ADDENDUM NO. 05

PROJECT: South Orangetown Central School District
PHASE 2: 2022 BOND

CPL PROJECT NO. 14457.20

DATE: November 19, 2024

1 AREA C1 - FINISH FLOOR PLAN
1/8" = 1'-0"

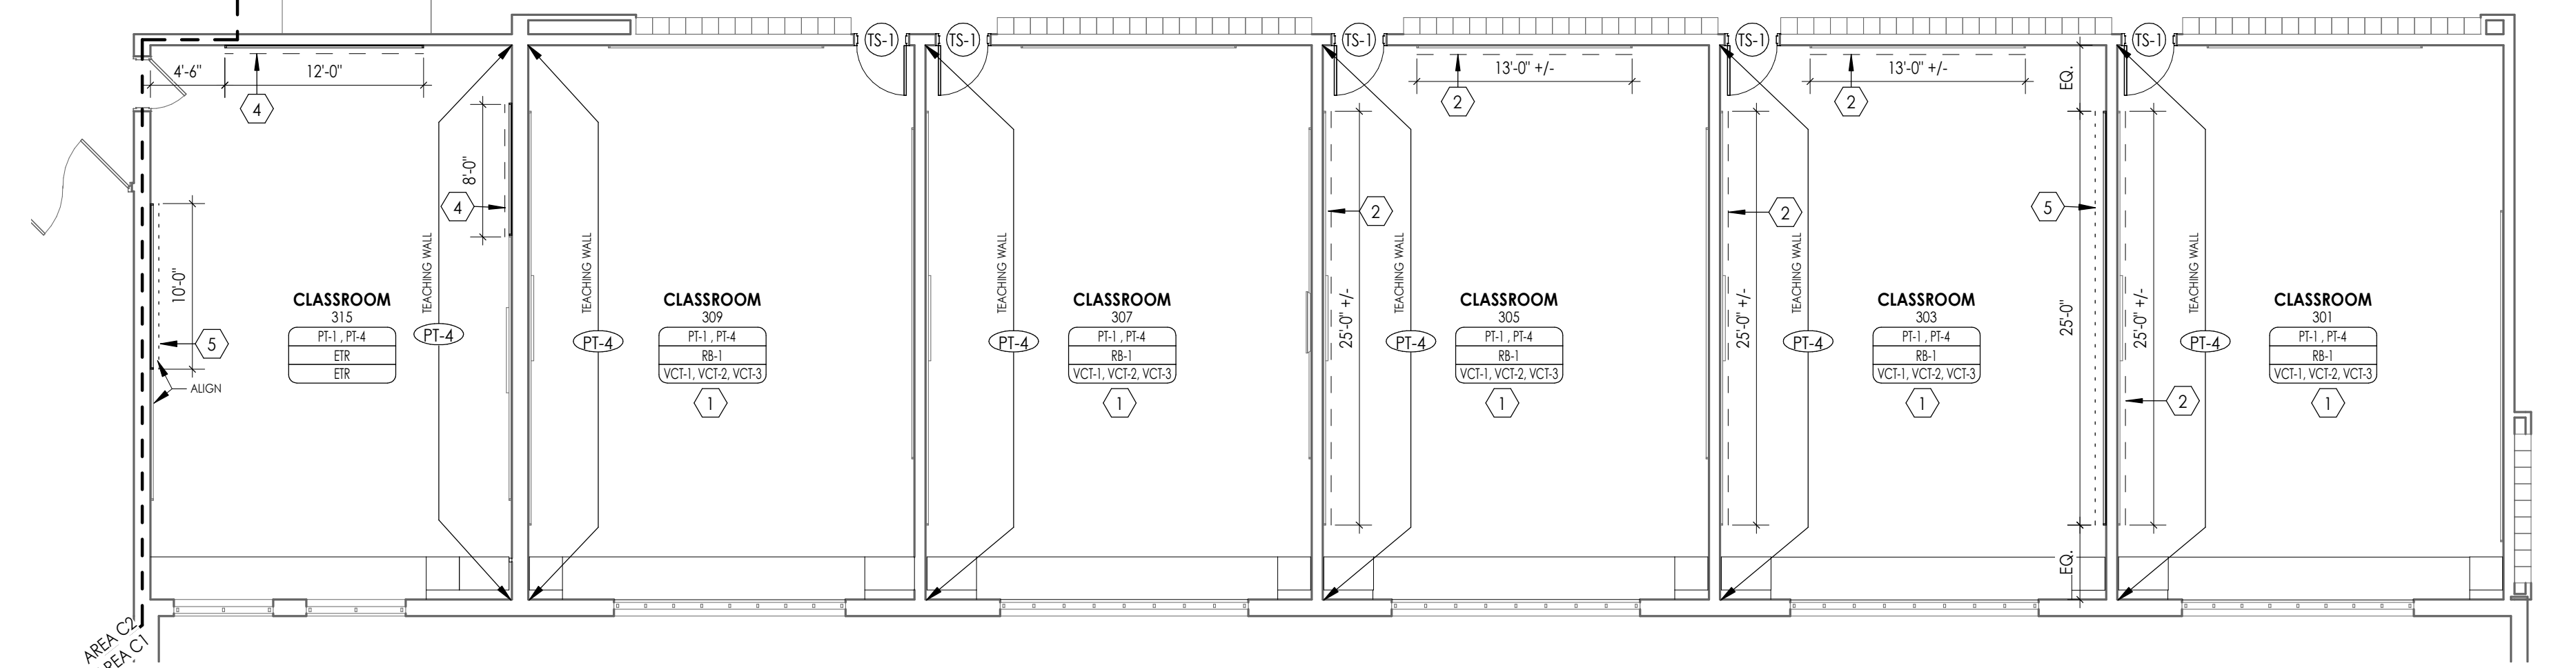
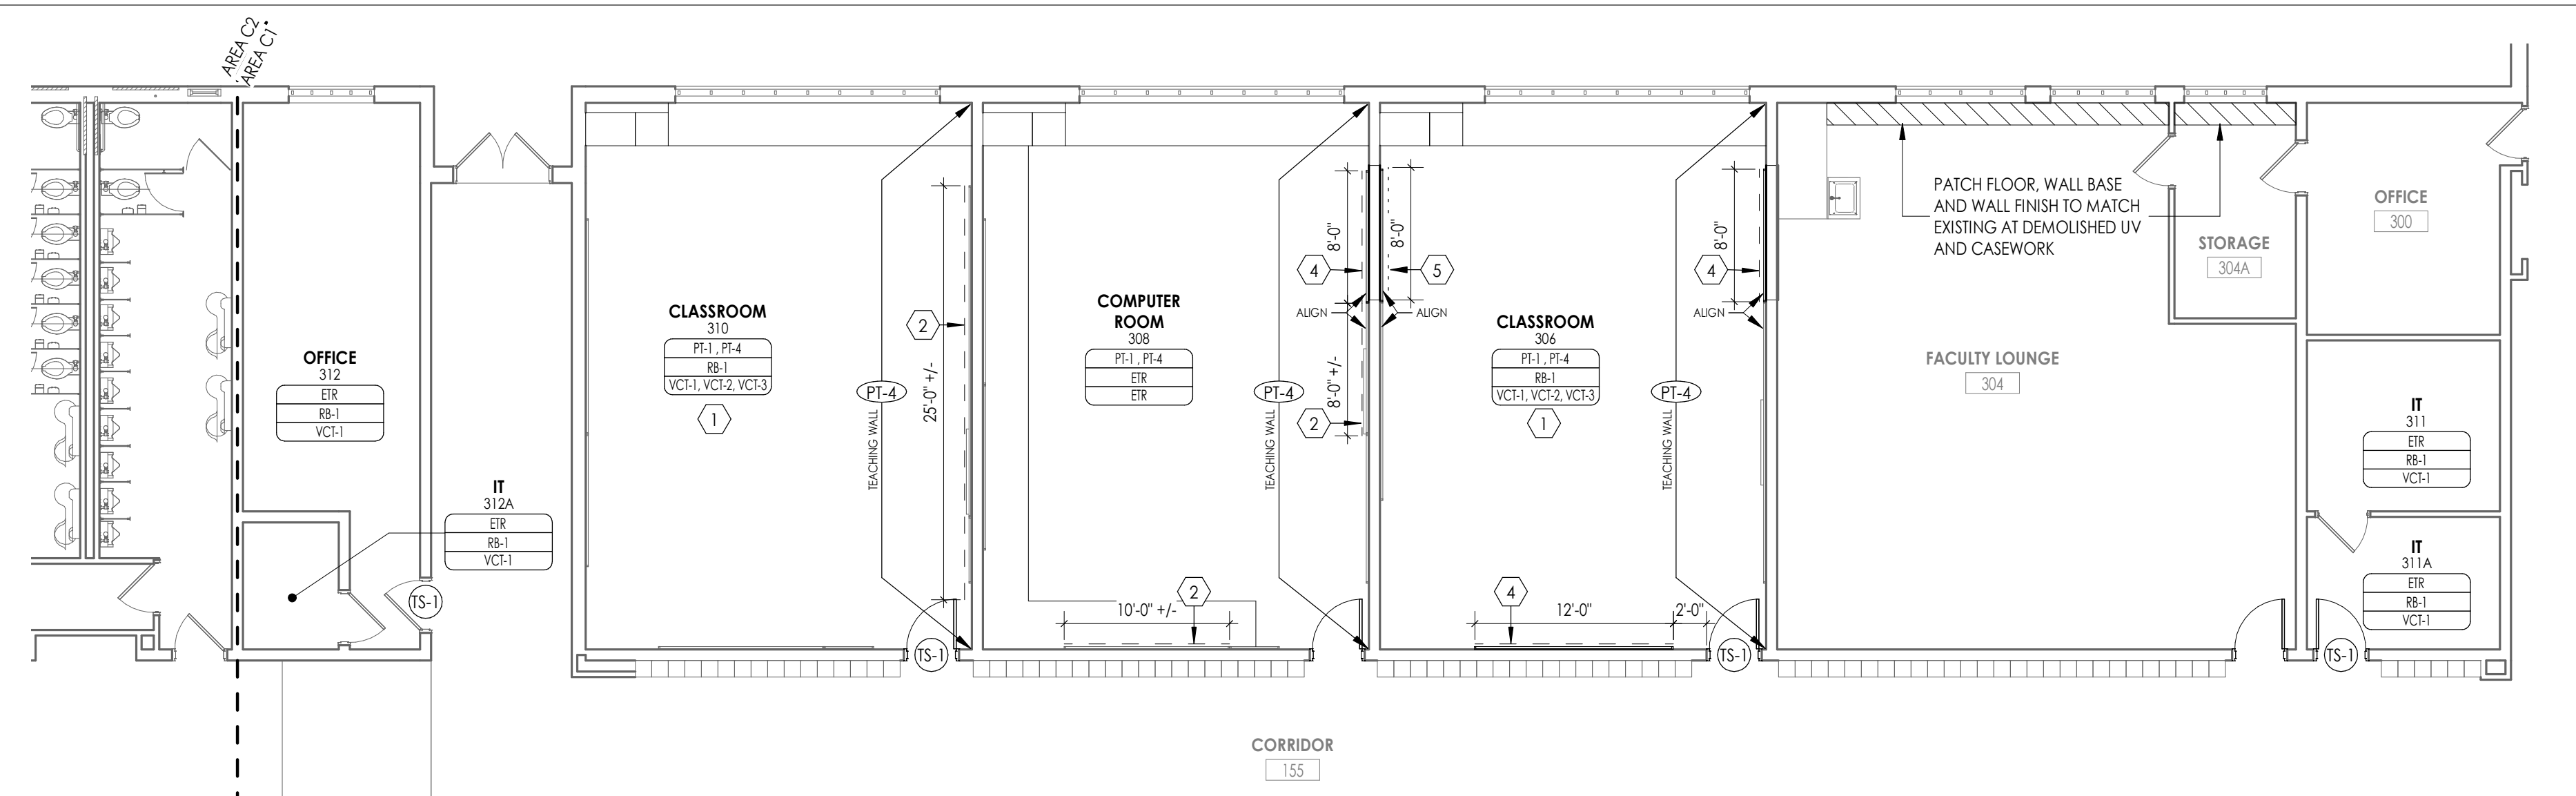
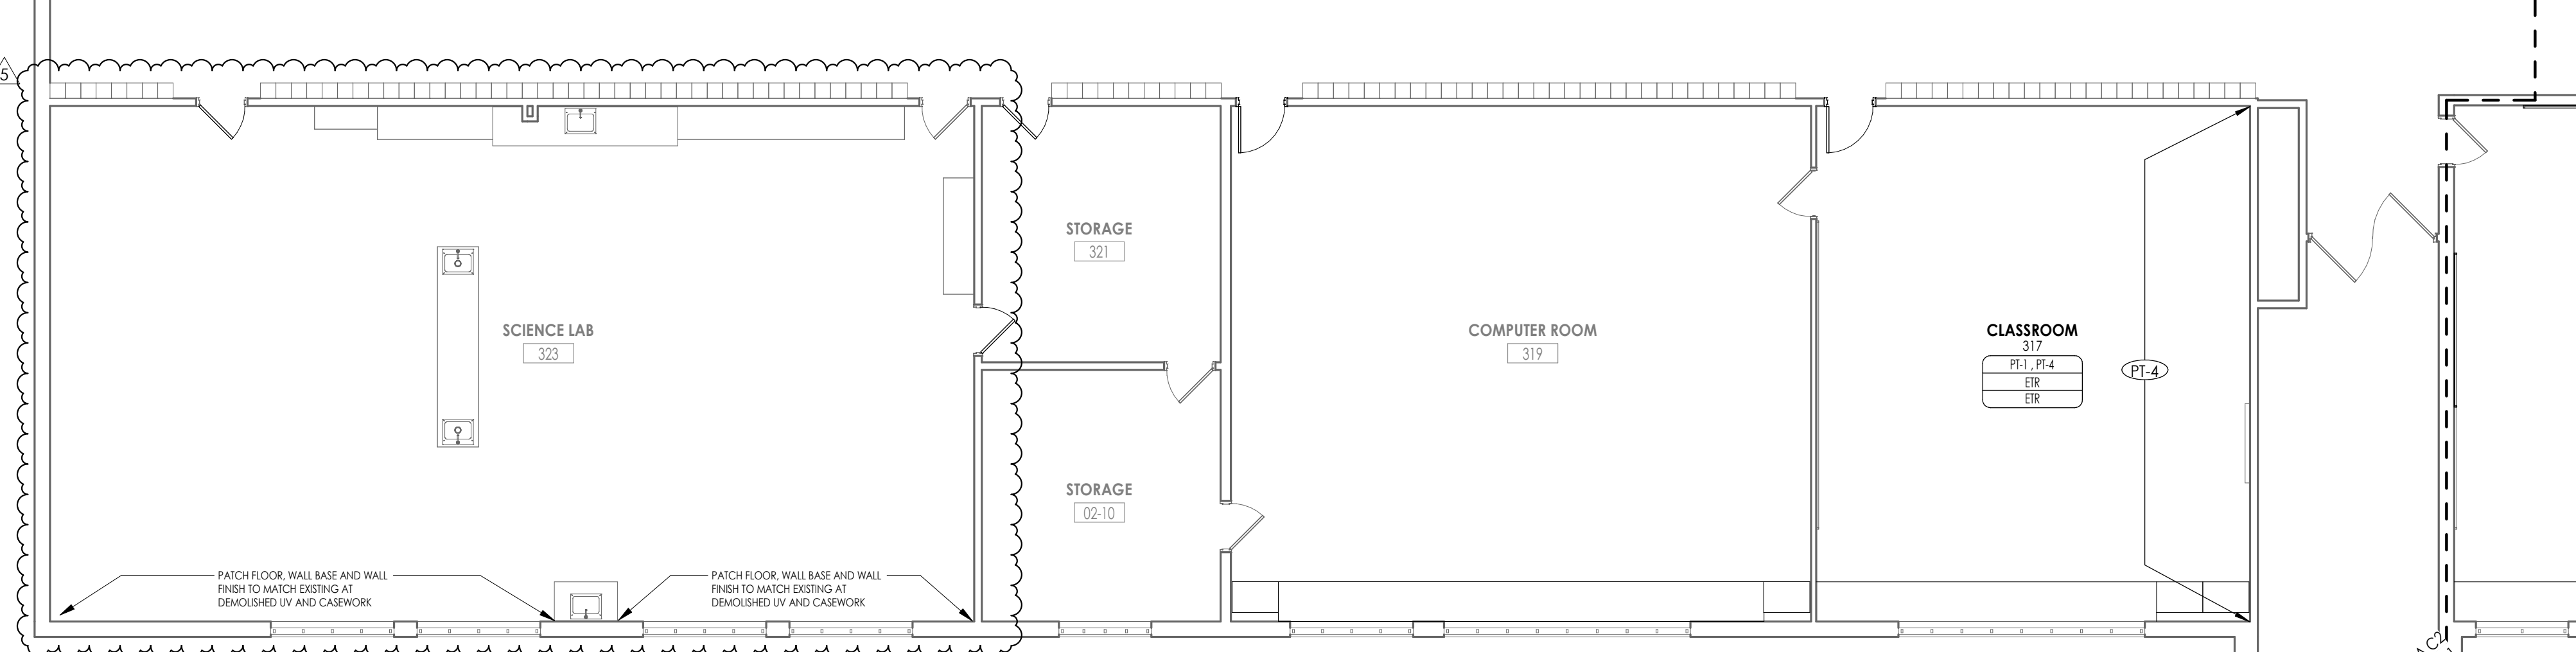
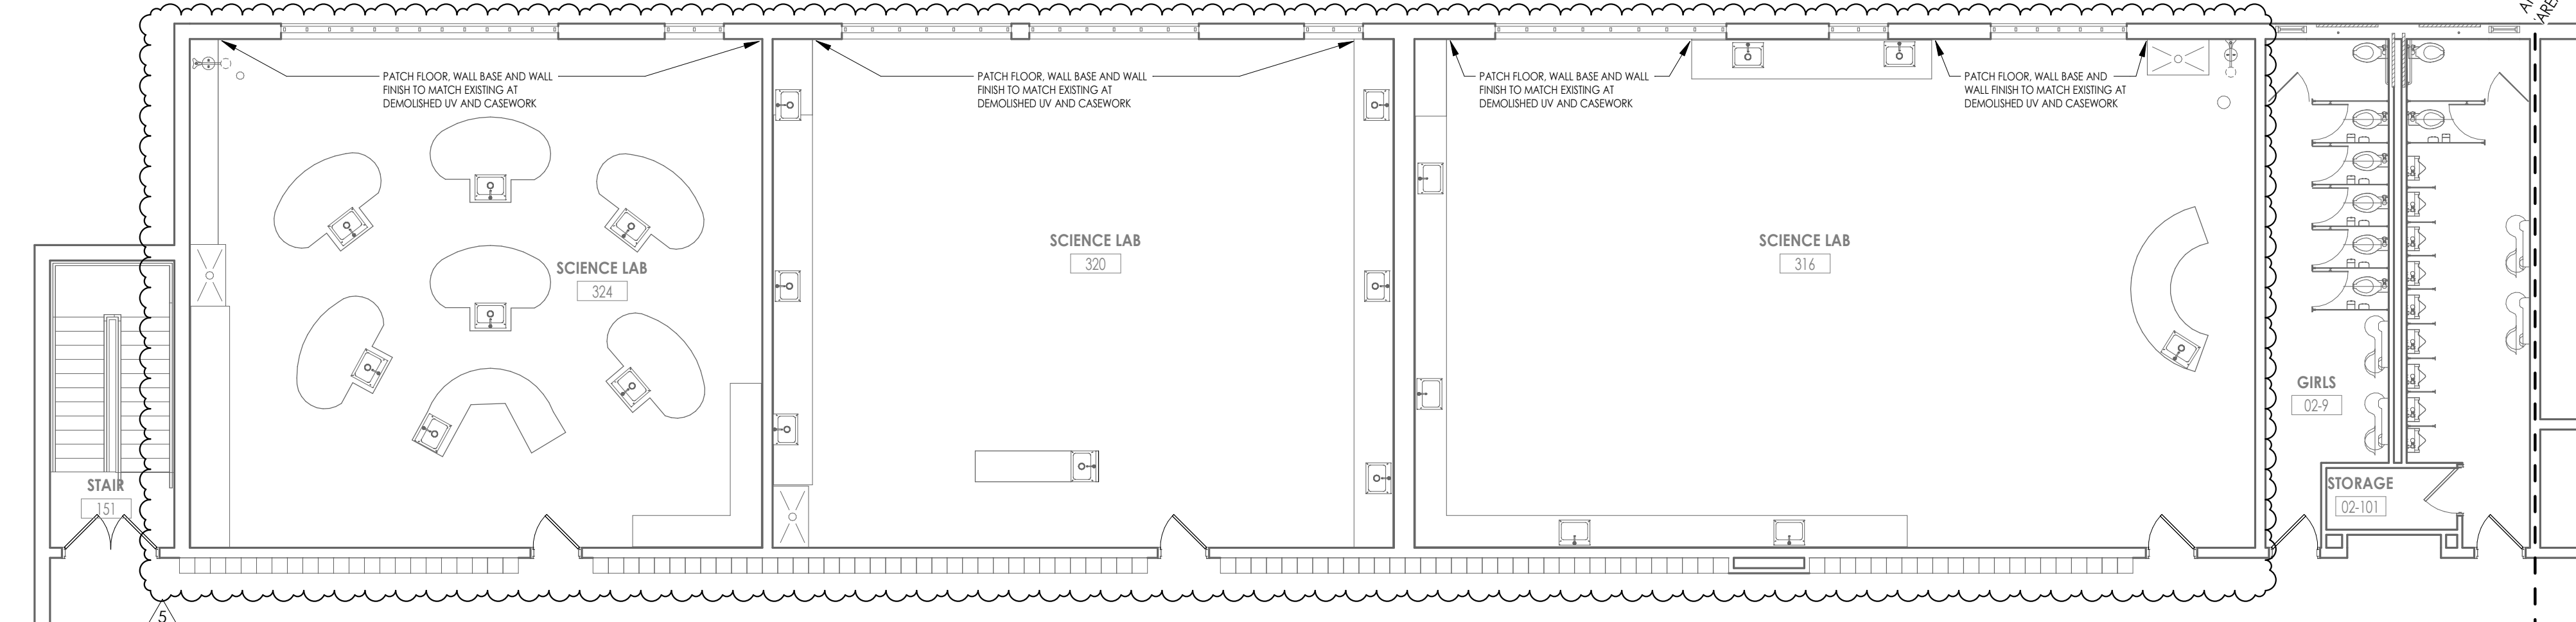
- 3.14 Drawings I201, I202 & I203: FINISH PLAN KEY NOTES LEGEND;
 - a. REVISE KEYNOTE 6 as follows: "ETR WOOD PANELING ALONG TOP OF WALL TO RECEIVE PT-1, FULL EXTENT OF ROOM."
